RE: Request for further information – DA no. 10.2021.630.1, Clarkes Beach Coastal Protection Works, 2 Massinger Street, Byron Bay

WRL Ref: WRL2020065 JTC LR20220304

Geobag works fronting Clarkes Beach Café and Reflections Holiday Park, Byron Bay

Figure 1: Seawall end effect variables (Figure 7.3 in WRL, 2021)

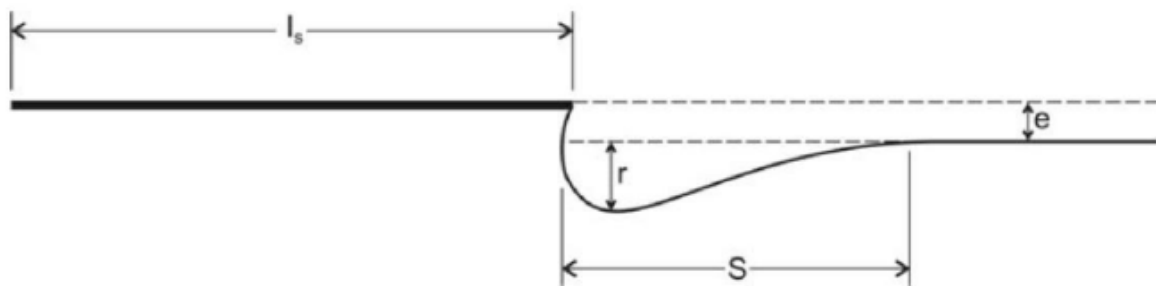
Can you please provide specific coastal engineering advice as to the potential impacts of the geobag structures on coastal land further along Main Beach and beyond over the proposed 5 year life of the development?

End effects estimates were detailed in Table 7.2 of WRL (2021) using two techniques. The form of end effects is shown in Figure 1.
